# Addendum Number One (1)

## **New Baseball Stadium Athletic Complex Facility – Phase 2 Louisiana State University Eunice Eunice, LA**

**State of Louisiana  
Office of Facility Planning and Control  
Project No.: 19-605-22-02, F.19002637  
Site Code: 4-01-006**

**Issue Date:** April 10, 2026

M2.21R1

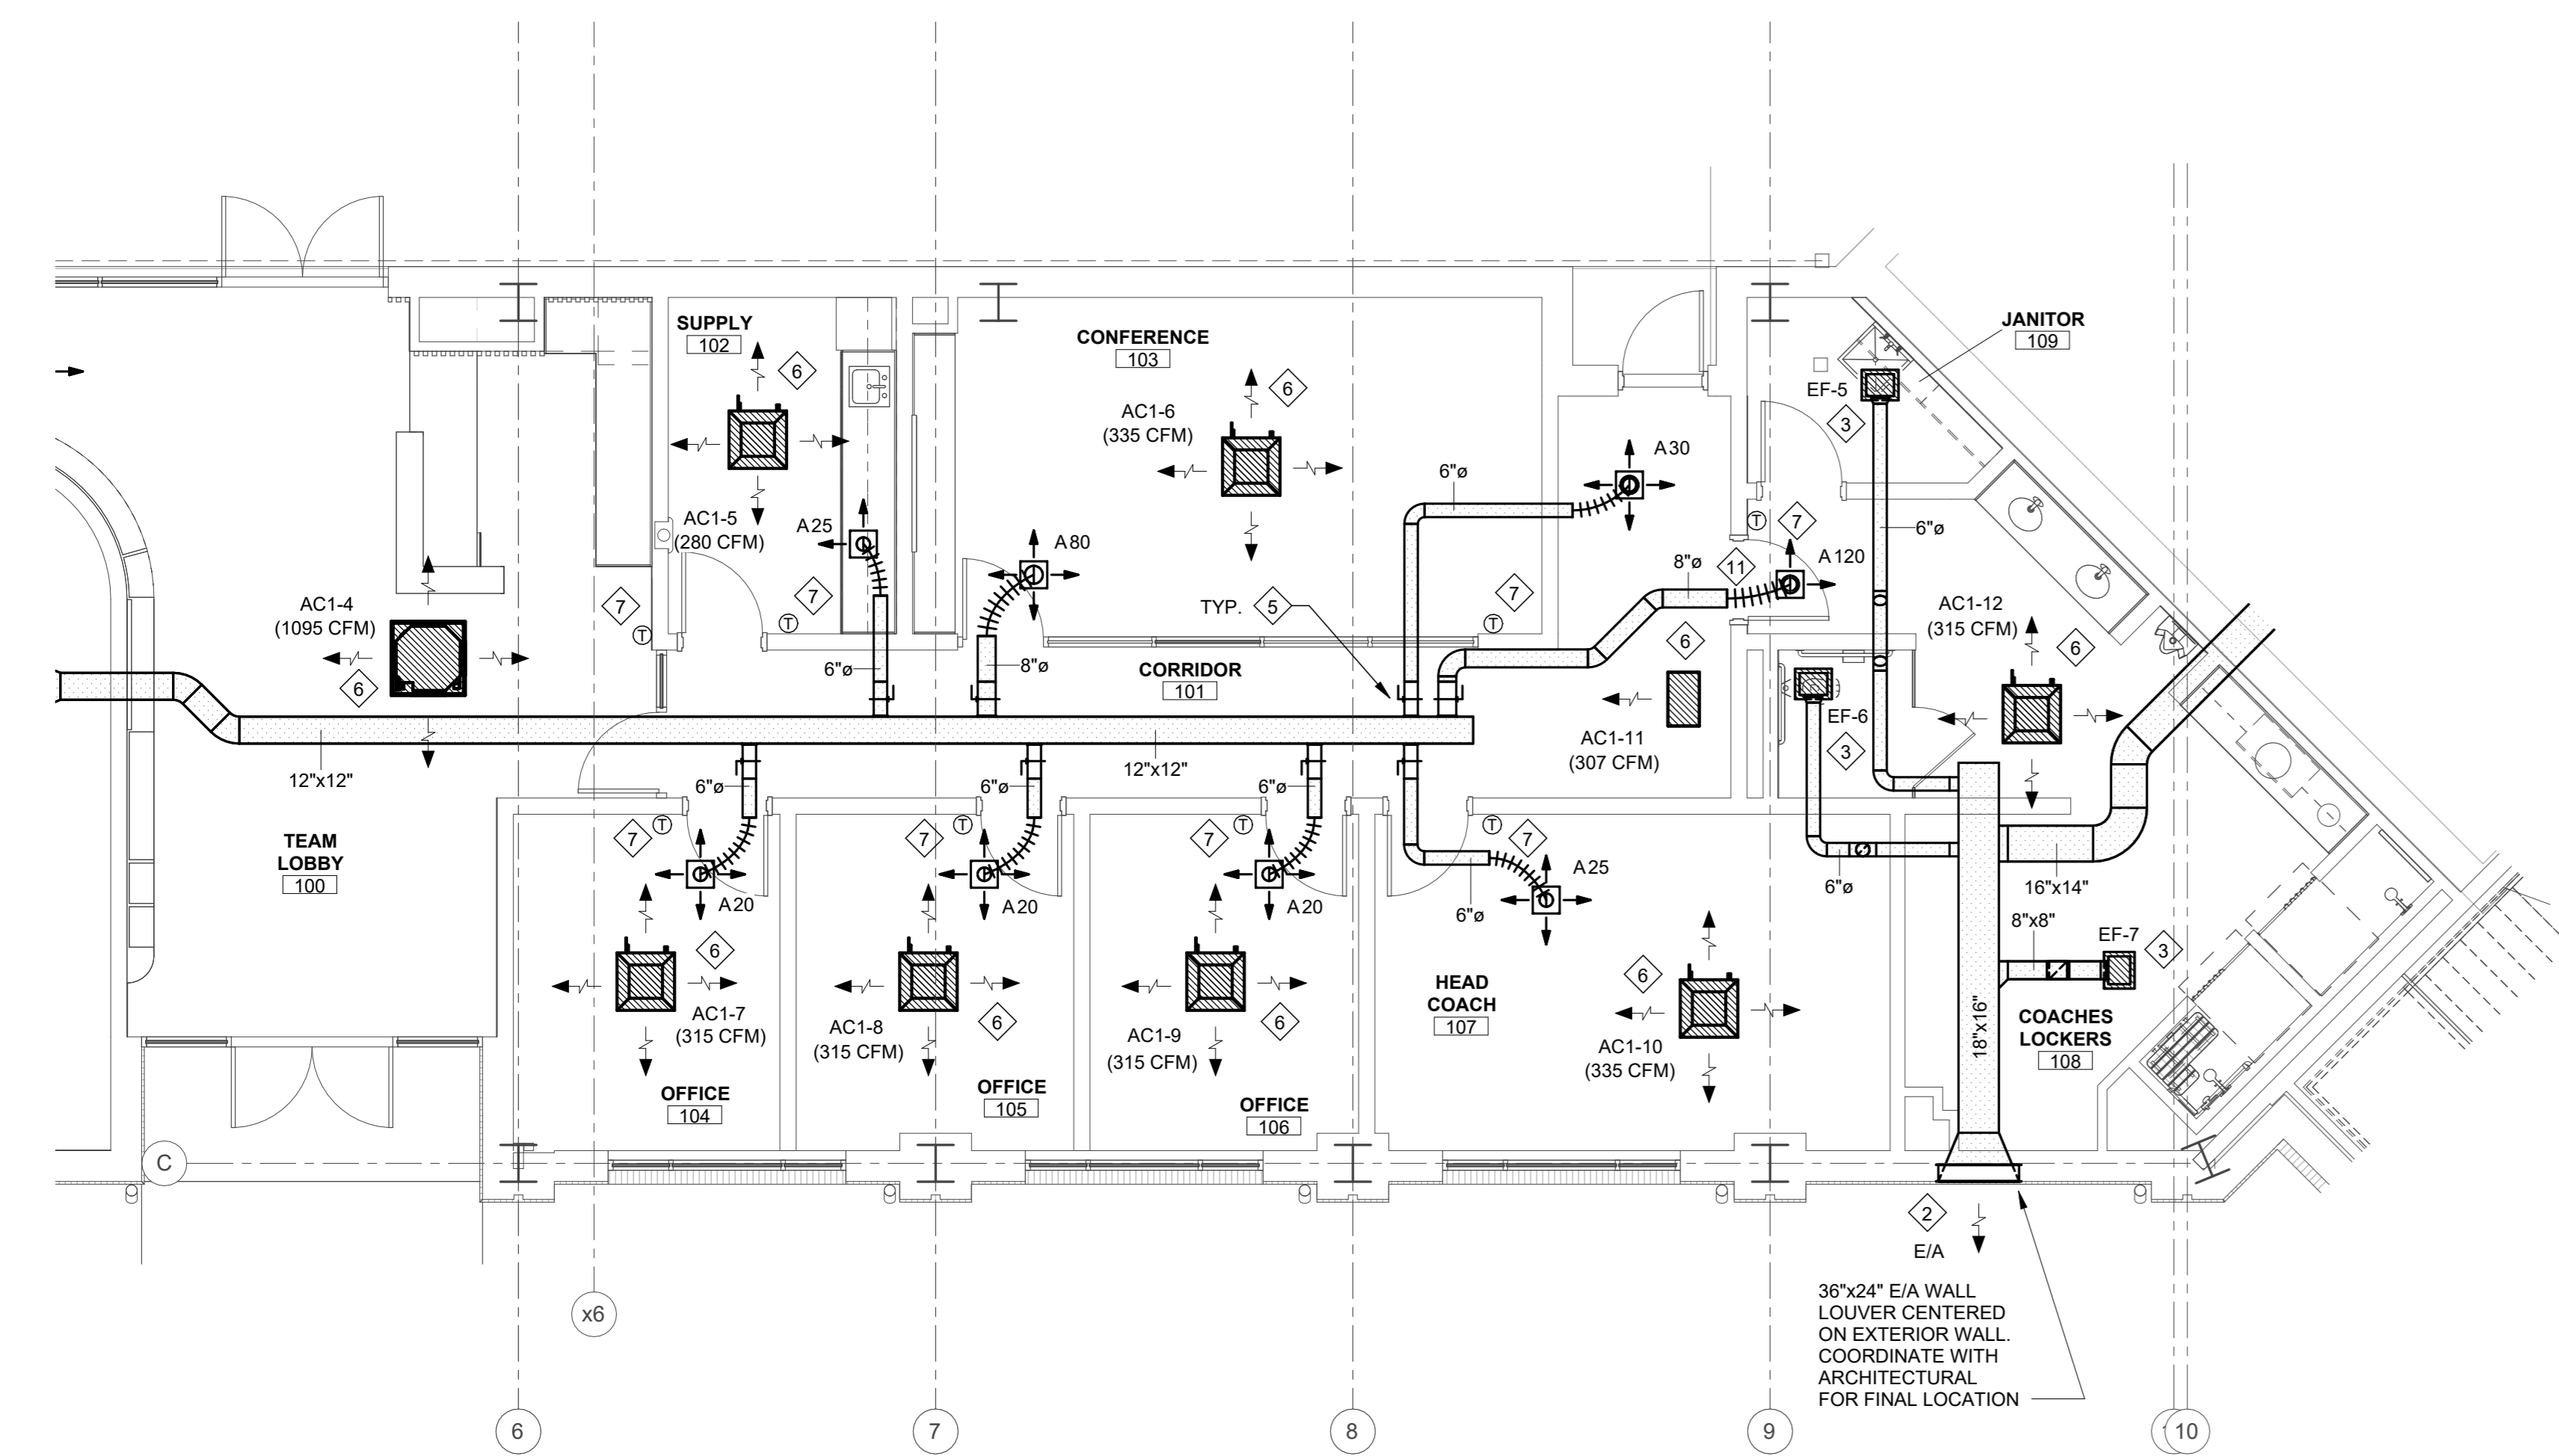
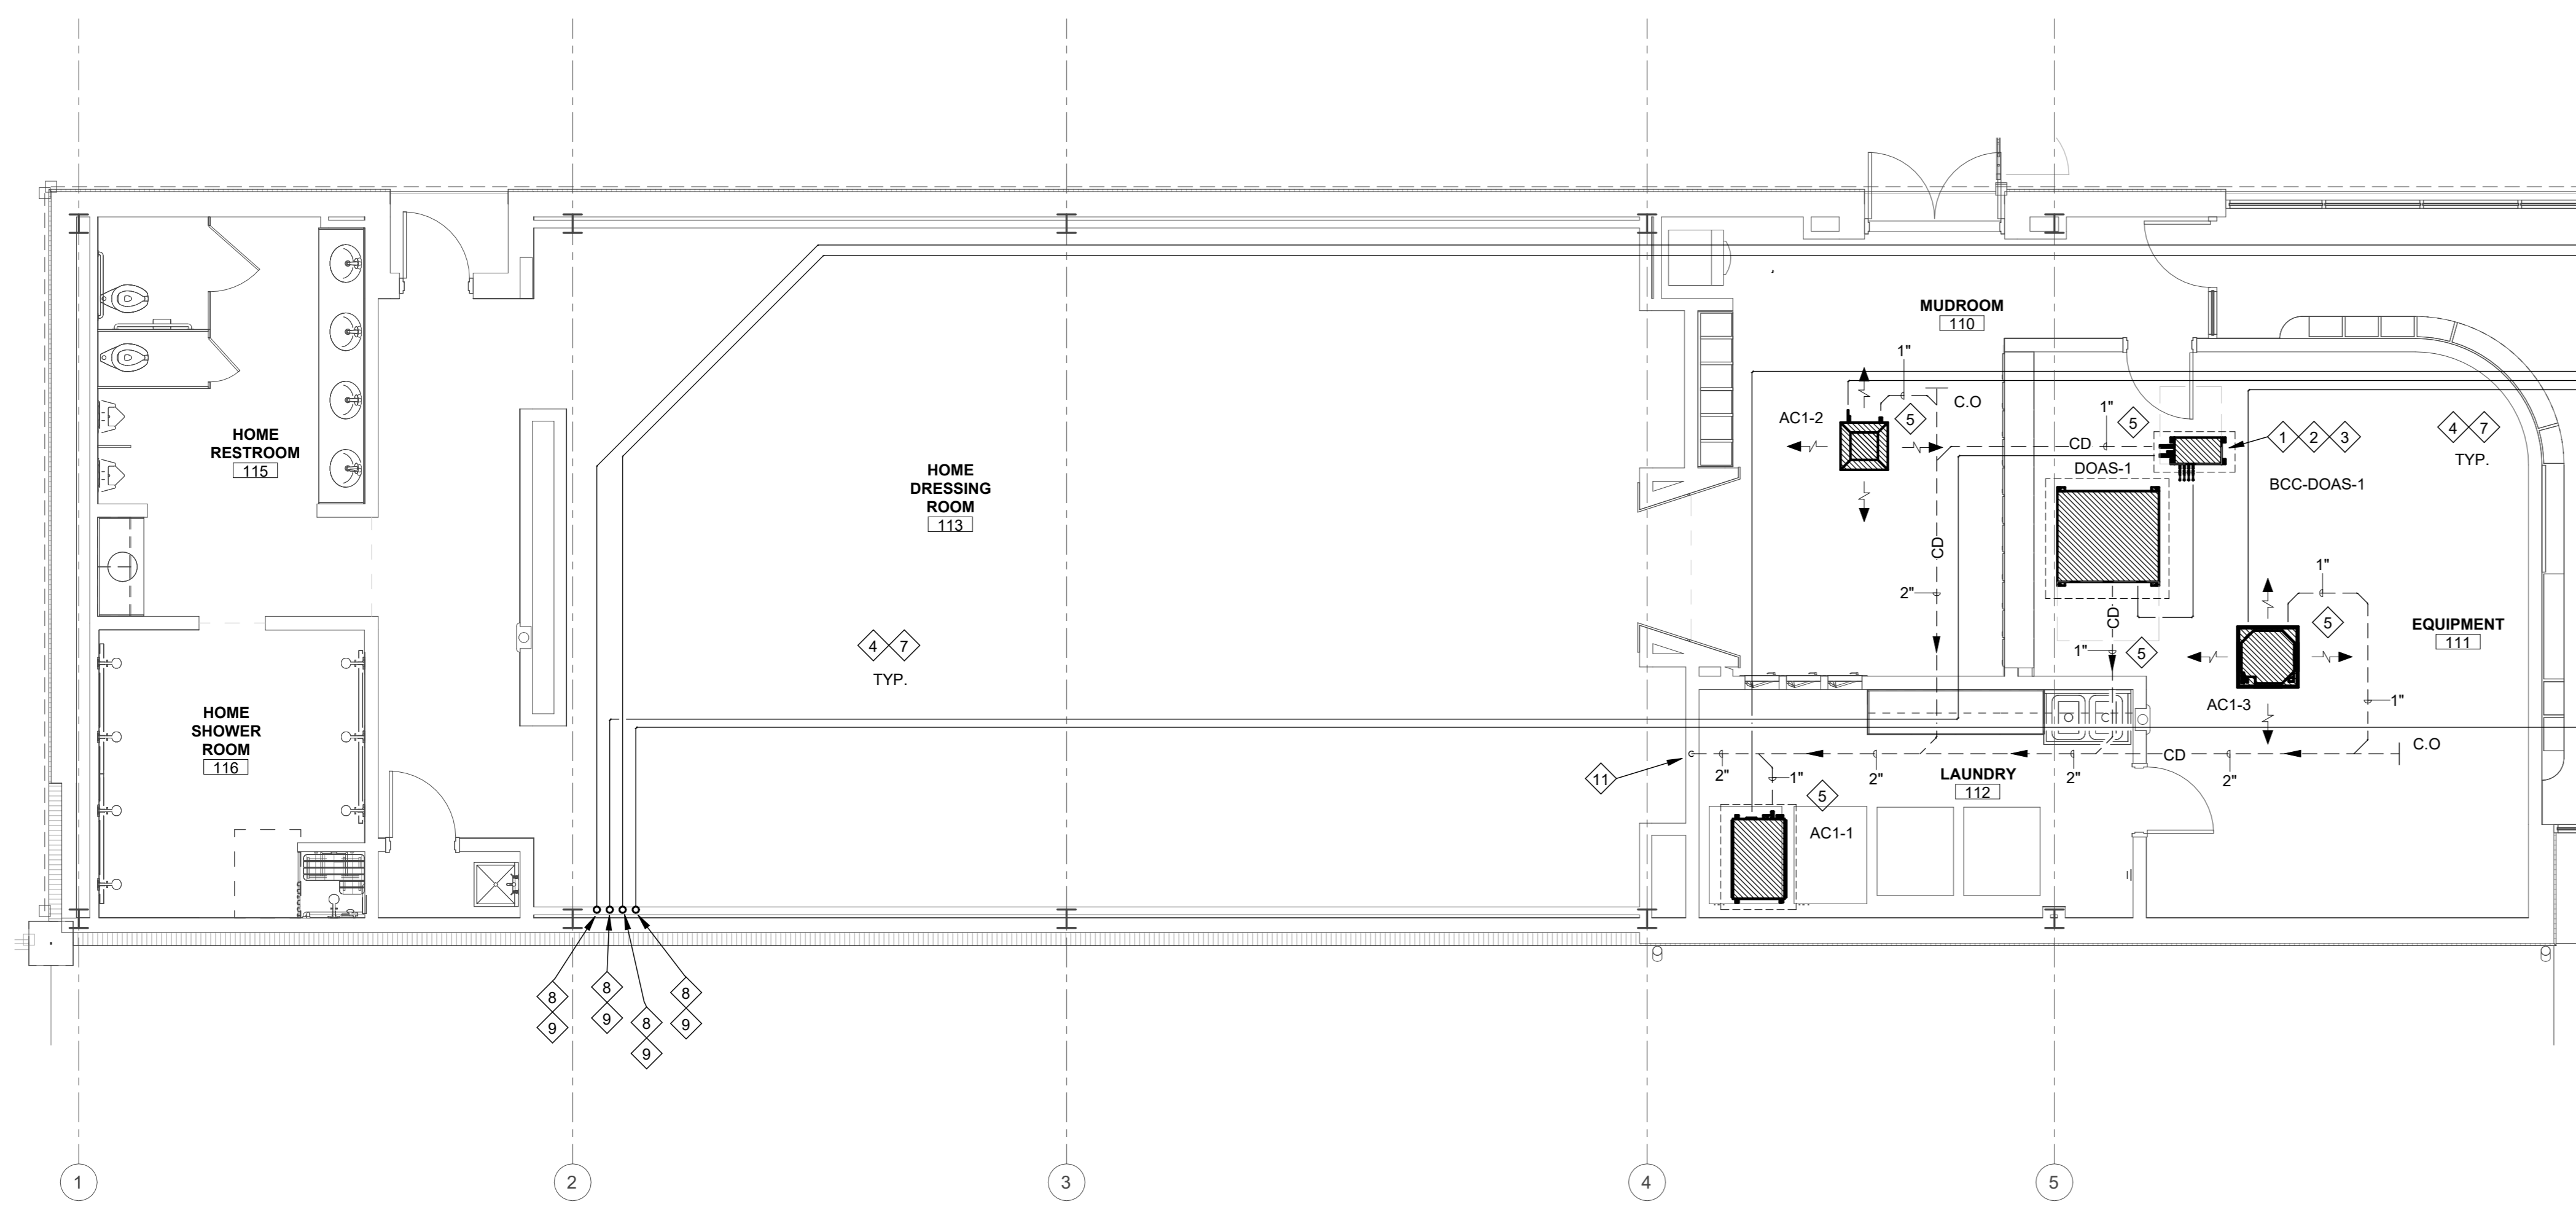
41. M2.21 – Sheet has been revised to modify ductwork and rough-ins for Commissary/Kitchen
42. M3.21 – Sheet has been revised to modify HVAC piping for Commissary/Kitchen

**E3.02R1**

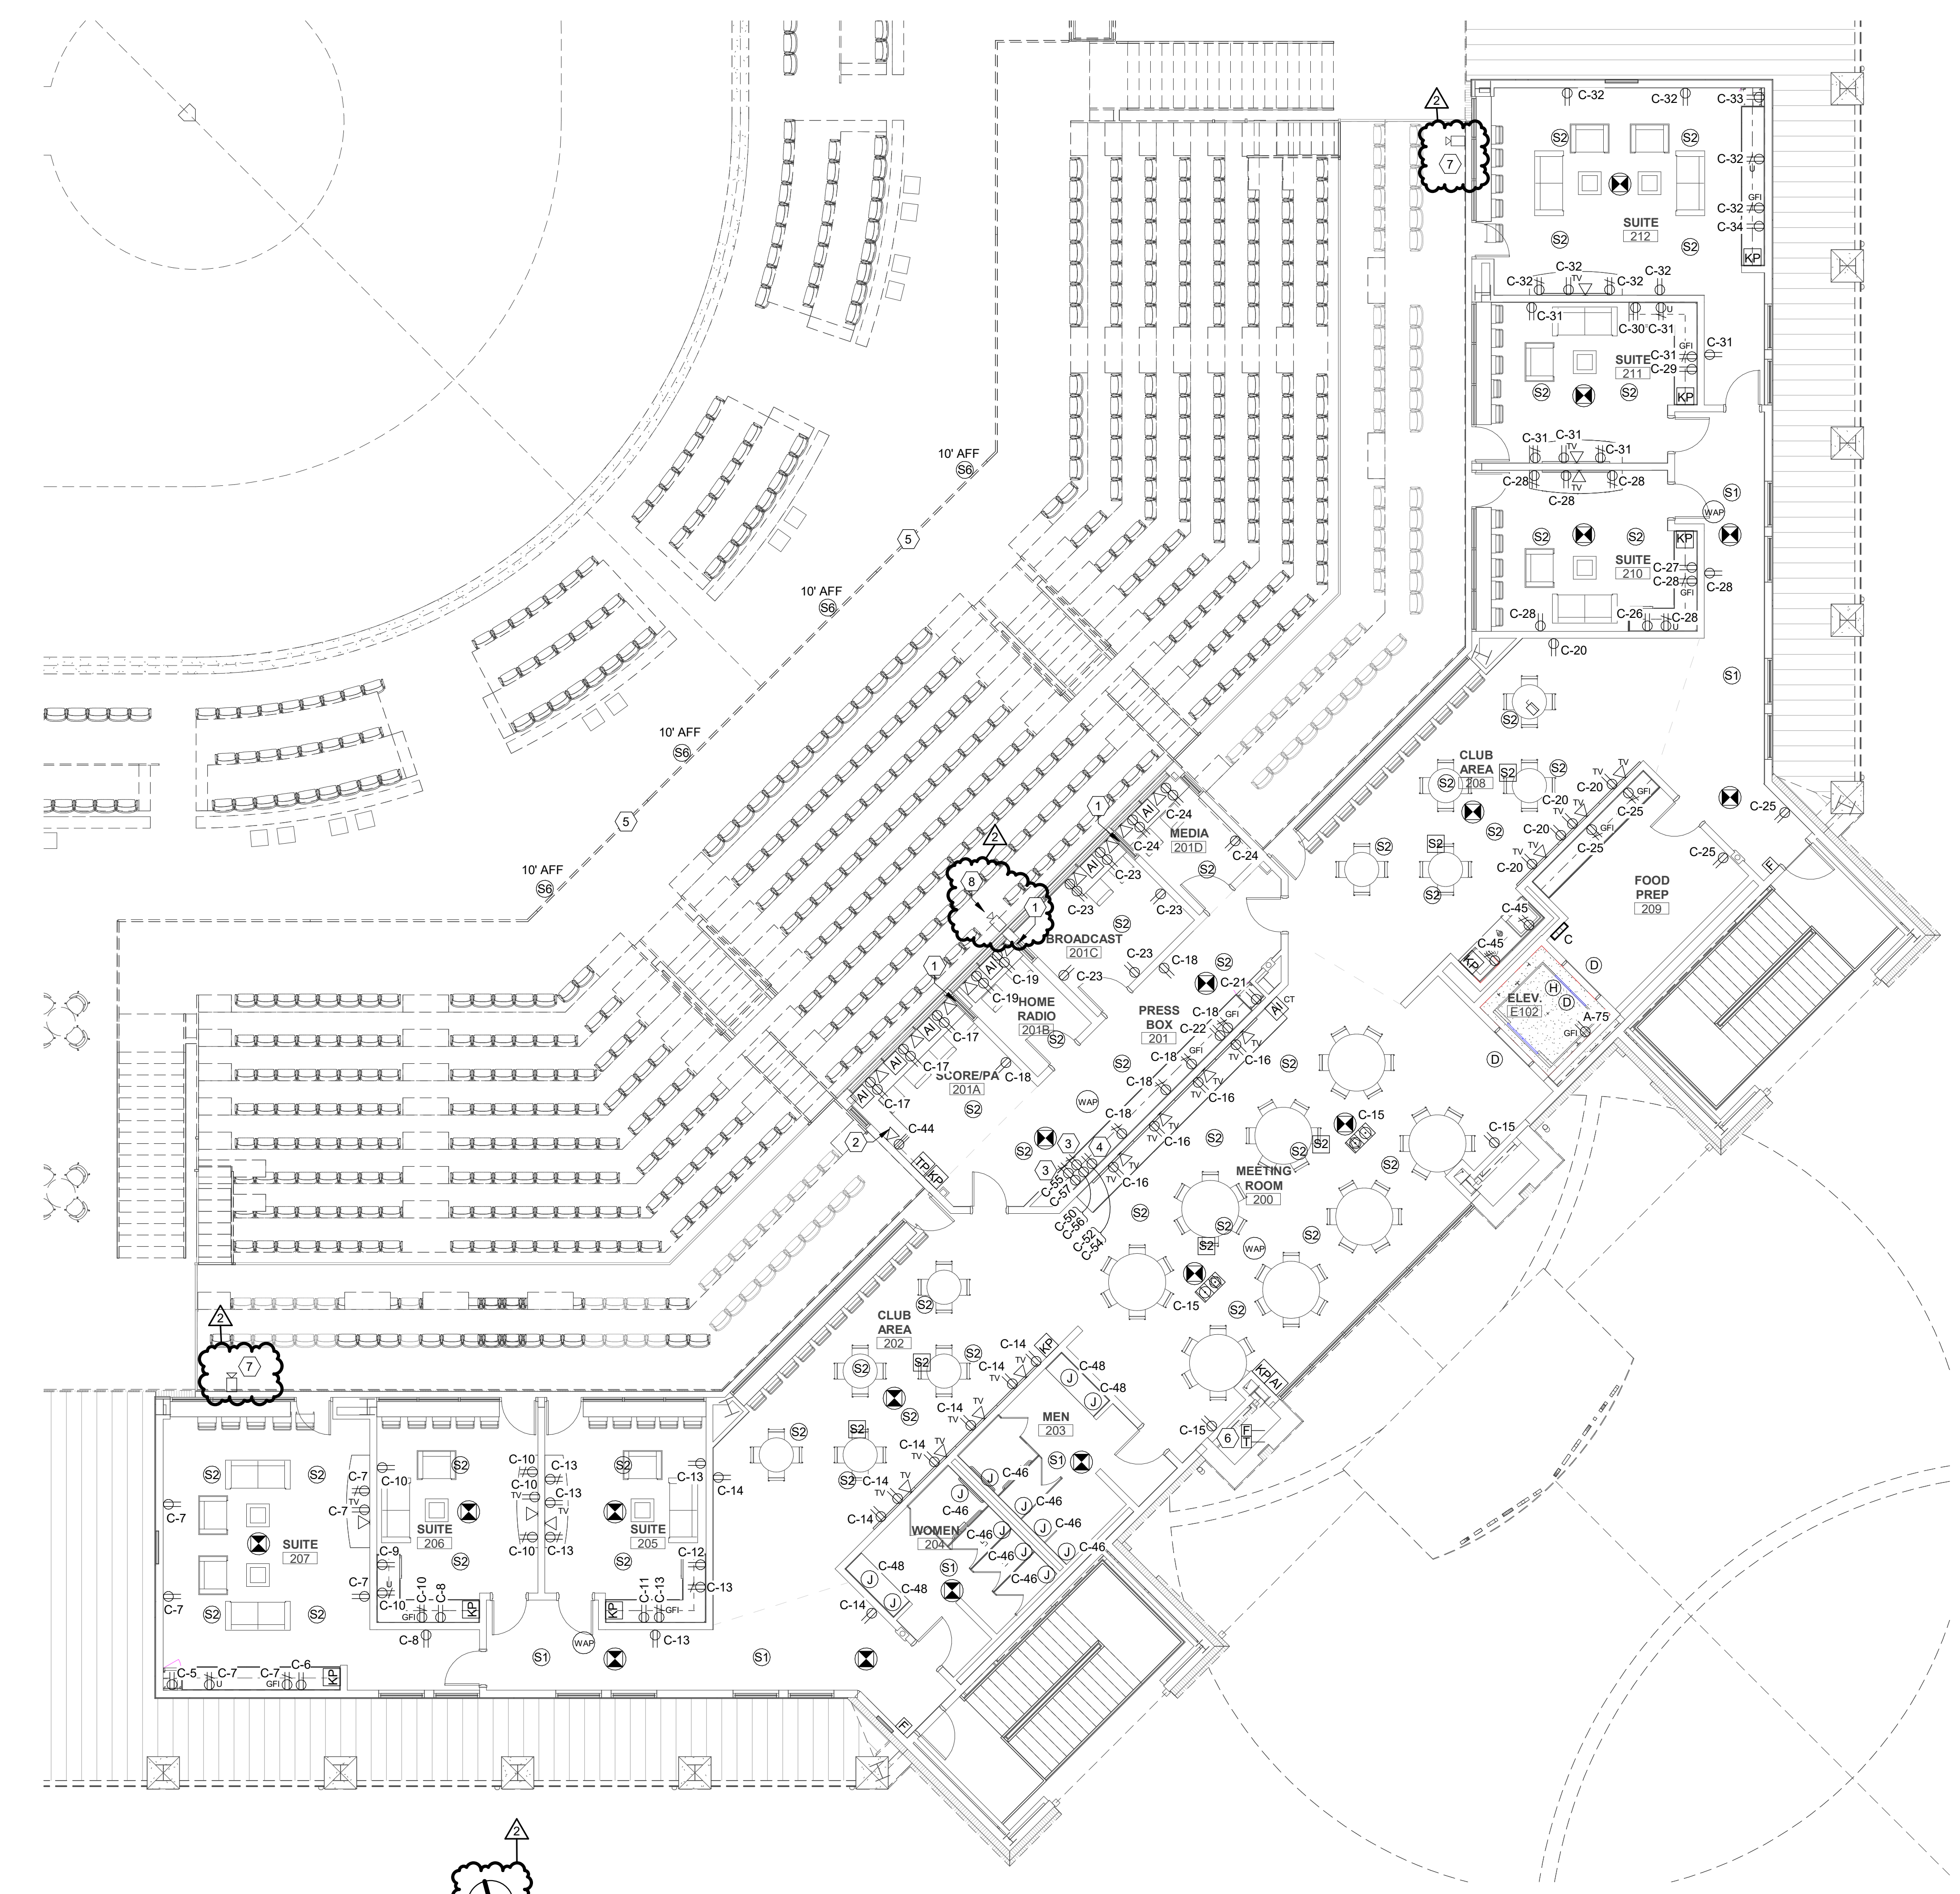
11. Electrical General Clarifications:
  - a. Contractor shall provide UPS (APC BN1350M2 or approved equivalent) for scoreboard controller in press box. UPS location shall be in approximate area indicated by keynote #2 on the attached sheet E3.02

- b. Stadium sound system rack is located in the south-west corner of the press box. Refer to the attached sheet E3.02 keynote #3 for location of receptacles dedicated to sound rack. Verify final exact location with Architect in field prior to rough-in.

- a. Contractor shall provide UPS (APC BN1350M2 or approved equivalent) for scoreboard controller in press box. UPS location shall be in approximate area indicated by keynote #2 on sheet E3.02R1.
- b. Stadium sound system rack is located in the south-west corner of press box. Refer to sheet E3.02R1 keynote #3 for location of receptacles dedicated to sound rack. Verify final exact location with architect prior to rough-in.
